**POWERLINK'S RESPONSE TO THE PROPOSED CODE CHANGES RELATING TO
THE NECA TRANSMISSION AND DISTRIBUTION PRICING REVIEW**

Response to ACCC – Network Pricing Code Changes Emanating From the Transmission & Distribution Pricing Review

Powerlink Queensland

Date: 29 September 1999

Figure 1 - Proposed NECA Process

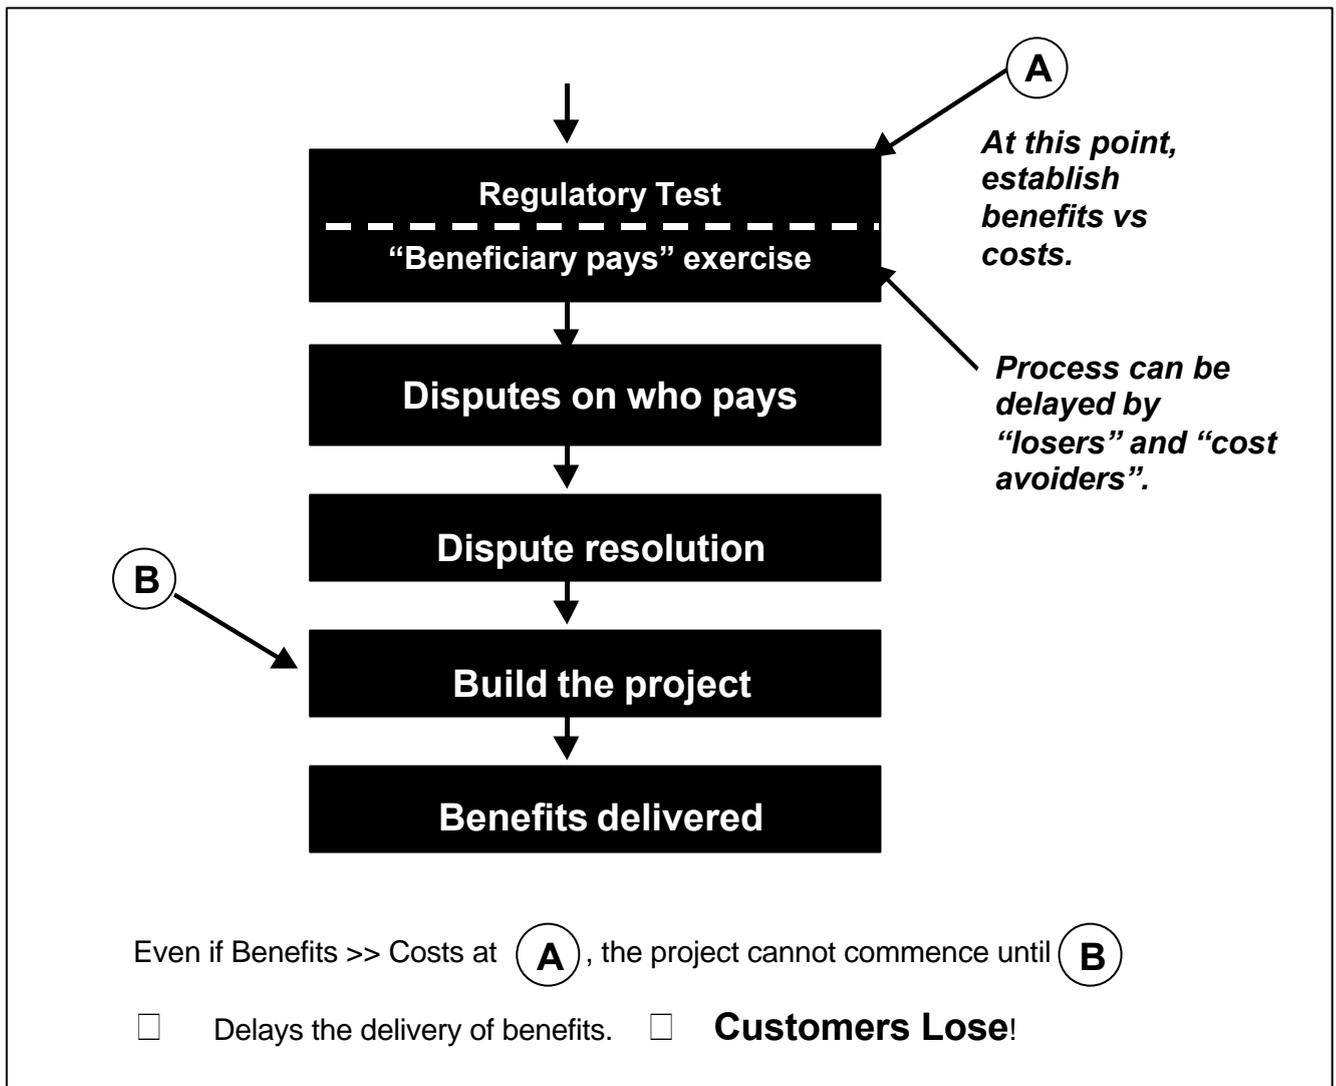
The **fundamental problem** rests with the **“Beneficiary pays”** part of the process and not with the Regulatory Test per se.

- The **“beneficiary pays”** part of the process – as currently defined – provides **ample opportunities for the “losers” and “cost-avoiders” to delay the whole augmentation** (not just the allocation of transmission charges). The process – as defined – is based on assumptions of generator behaviour, which are easy to challenge; the process can go on indefinitely (no time limit) as “losers” challenge the proponent to model more and more different combinations of assumptions; and there is no “fallback” or default allocation which would bring the process to a firm conclusion in the absence of “convergence” by all parties

The “bundling” of the “beneficiary pays” exercise into the Regulatory test itself.

By contrast, the “beneficiary pays” exercise requires a single answer i.e. it must be determined by a single set of assumptions of generator behaviour. This is clearly going to be contentious – as outlined above, even those not required to pay, the “losers”, can frustrate and delay the process by challenge. If the “winners” include generators (e.g. upstream generators), then they have a commercial incentive to argue for a minimal allocation of the costs (vs costs allocated to customers). Again, this serves to delay the augmentation.

2. There is no ‘default’ cost allocation

If there was a “default” cost allocation, and a time limit, then the process could reach a firm conclusion.

Figure 2 - Suggested Revised Process

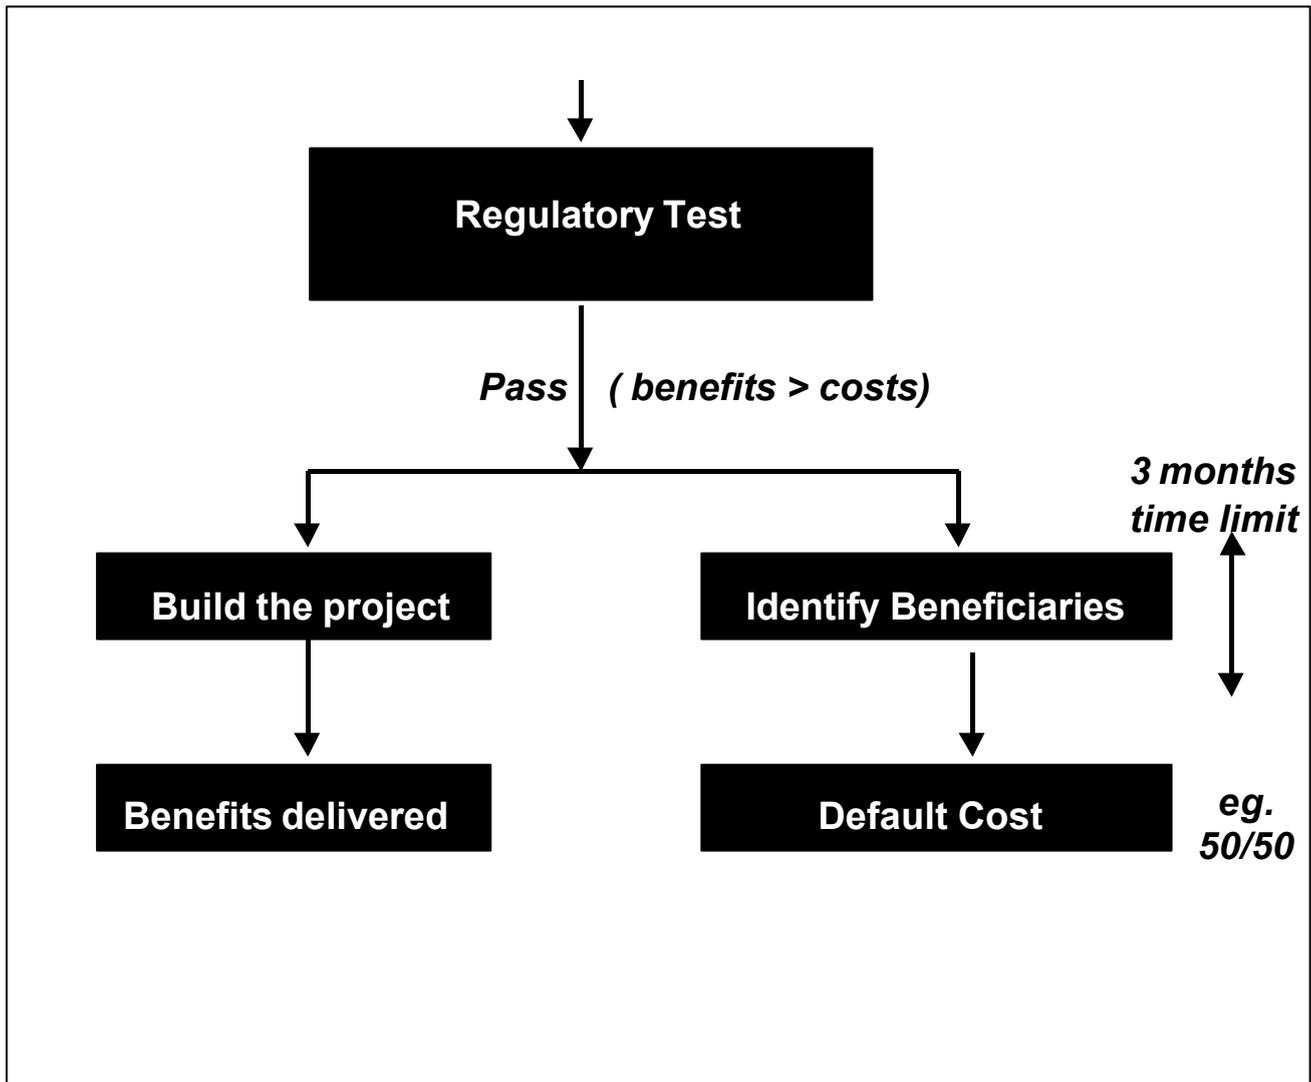
The Solution

1. **Separate** the "beneficiary pays" part of the process from the Regulatory Test proper.
2. If the augmentation passes the Regulatory test, the proponent does 2 things **in parallel**:
 - (a) commences the project – this ensures earliest delivery of the benefits, and
 - (b) undertakes the "beneficiary pays" exercise
3. The "beneficiary pays" exercise to have a time limit of 3 months.
4. If there is no convergence after that time, a "default" cost allocation (eg 50/50 generators and customers) applies.

Delete **clause 5.6.2.(g) (2)** and delete the words *“and allocation”* in the final para of **5.6.2 (g)**

Replace **clause 5.6.2.(h) (2) B and C** with a new clause B
- *“whether the preferred option is to be a fully funded network option”*

Add a **new clause 5.6.2 (j1)** – to require the NSP to undertake the “beneficiary pays” exercise (unless it’s a fully funded option) and publish a report.

Add a **new clause 5.6.2 (j2)** – to enable ONLY those participants required to pay for the augmentation to make representations to the NSP within 40 business days and for the NSP to respond within 20 days.

Add a **new clause 5.6.2. (j3)** – to set a default cost allocation if there is no resolution after 3 months from the publication of the above cost allocation report.

Clause 6.14.3(d) Standby Charges

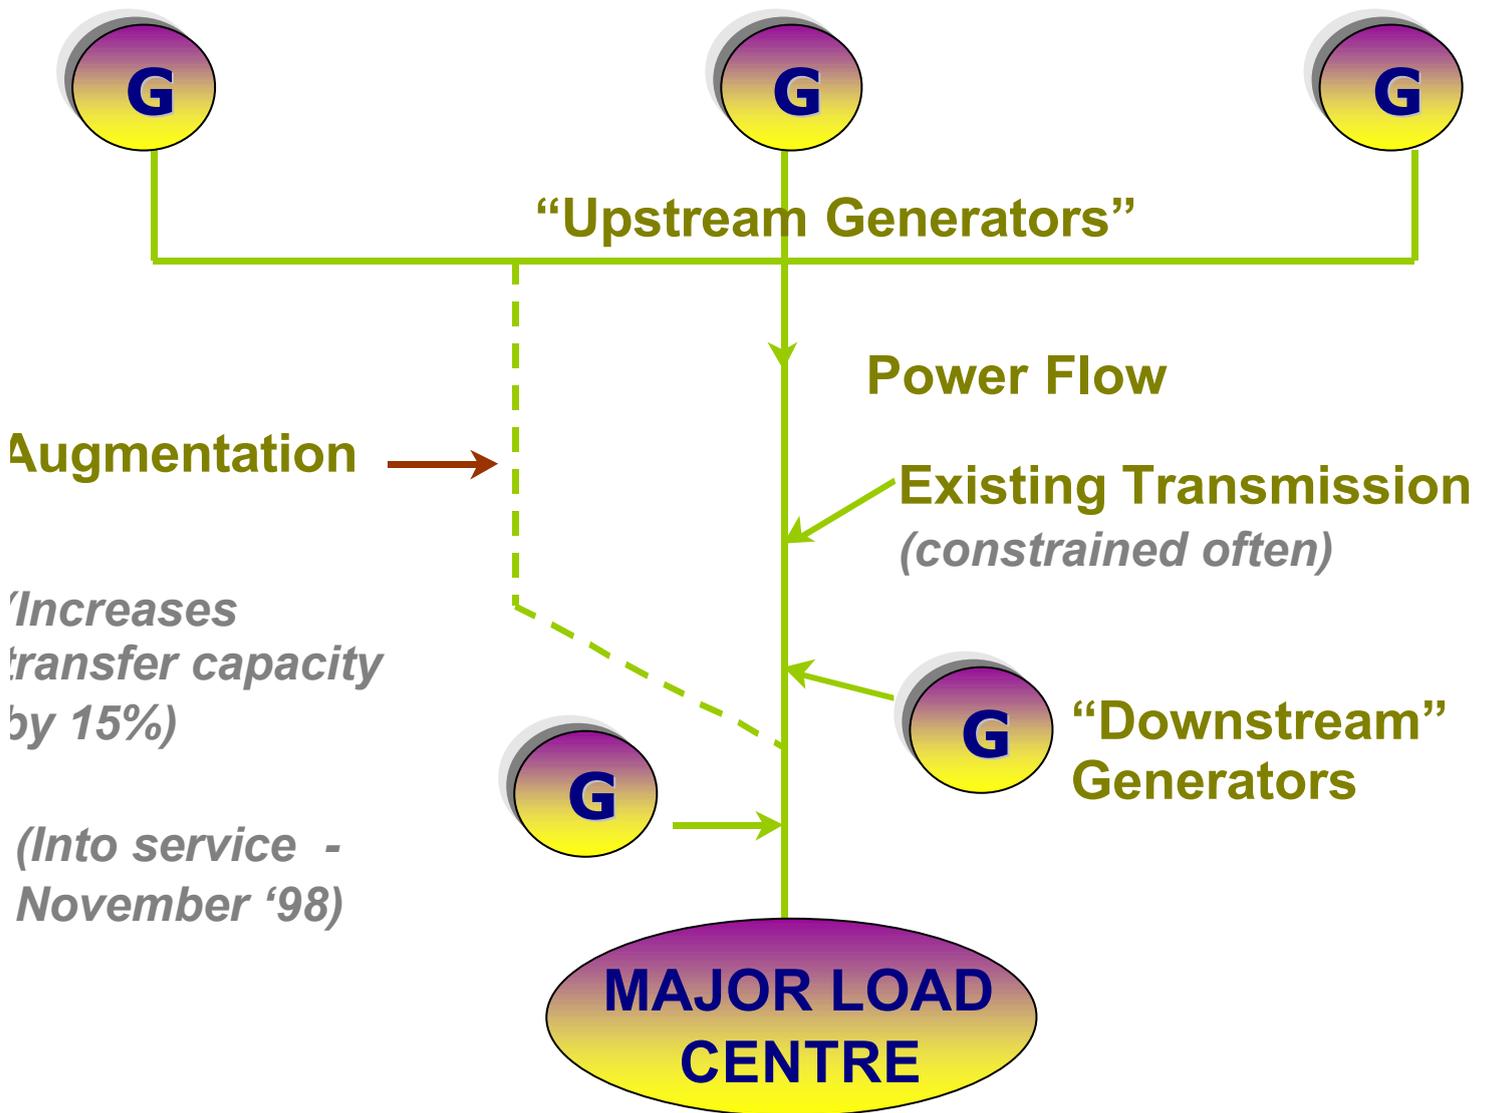
It is suggested that a corresponding clause be added to Part C to provide for negotiation of standby charges for transmission connected generator/customer pairs.
